Source: TSG CN WG 1
Title: CRs to R99 and older releases on Work Item GPRS
Agenda item: 7.13
Document for: APPROVAL

This document contains **23** CRs on **R99 and older releases** Work Item "GPRS", that have been agreed by **TSG CN WG1**, and are forwarded to TSG CN Plenary meeting #10 for approval.

Figure B.1: TOM Protocol Envelope format

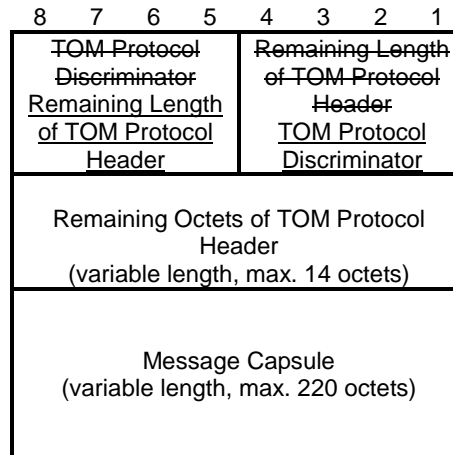
Reason for change:	⌘ Fig. B.1 is not consistent with sections B.1.1, B.1.2.
Summary of change:	⌘ Fig. B.1 is revised.
Consequences if not approved:	⌘

Figure 1: XID parameter field format

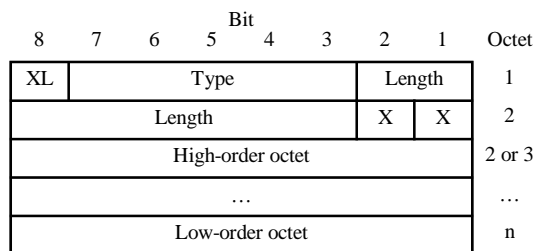
Reason for change:	⌘	The current version of 04.64 does not permit the negotiation of IOV-UI parameter after ciphering is enabled. However, according to the discussion in document N1-01196, IOV-UI negotiation must be permitted after ciphering has been enabled. Otherwise, the two LLC peers will never manage to negotiate a new IOV-UI value and will always use the default IOV-UI.
Summary of change:	⌘	<p>The CR proposes to remove the condition stating that the IOV-UI negotiation is allowed only before ciphering is enabled.</p> <p>In addition, the CR eliminates the need to specify the (missing) exception case where an attempt is made to negotiate IOV-UI after ciphering is enabled.</p>
Consequences if not approved:	⌘

Figure 1: XID parameter field format

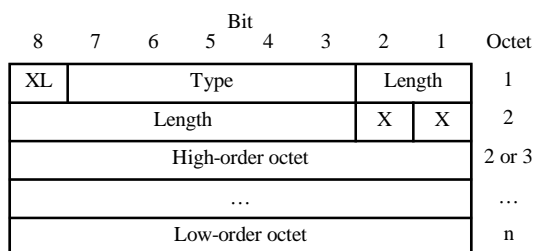
Reason for change:	⌘	The current version of 04.64 does not permit the negotiation of IOV-UI parameter after ciphering is enabled. However, according to the discussion in document N1-01196, IOV-UI negotiation must be permitted after ciphering has been enabled. Otherwise, the two LLC peers will never manage to negotiate a new IOV-UI value and will always use the default IOV-UI.
Summary of change:	⌘	<p>The CR proposes to remove the condition stating that the IOV-UI negotiation is allowed only before ciphering is enabled.</p> <p>In addition, the CR eliminates the need to specify the (missing) exception case where an attempt is made to negotiate IOV-UI after ciphering is enabled.</p>
Consequences if not approved:	⌘

Figure 1: XID parameter field format

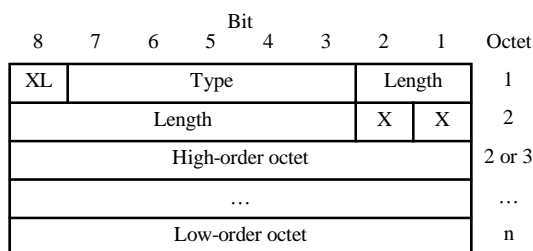
Reason for change:	⌘	The current version of 04.64 does not permit the negotiation of IOV-UI parameter after ciphering is enabled. However, according to the discussion in document N1-01196, IOV-UI negotiation must be permitted after ciphering has been enabled. Otherwise, the two LLC peers will never manage to negotiate a new IOV-UI value and will always use the default IOV-UI.
Summary of change:	⌘	<p>The CR proposes to remove the condition stating that the IOV-UI negotiation is allowed only before ciphering is enabled.</p> <p>In addition, the CR eliminates the need to specify the (missing) exception case where an attempt is made to negotiate IOV-UI after ciphering is enabled.</p>
Consequences if not approved:	⌘
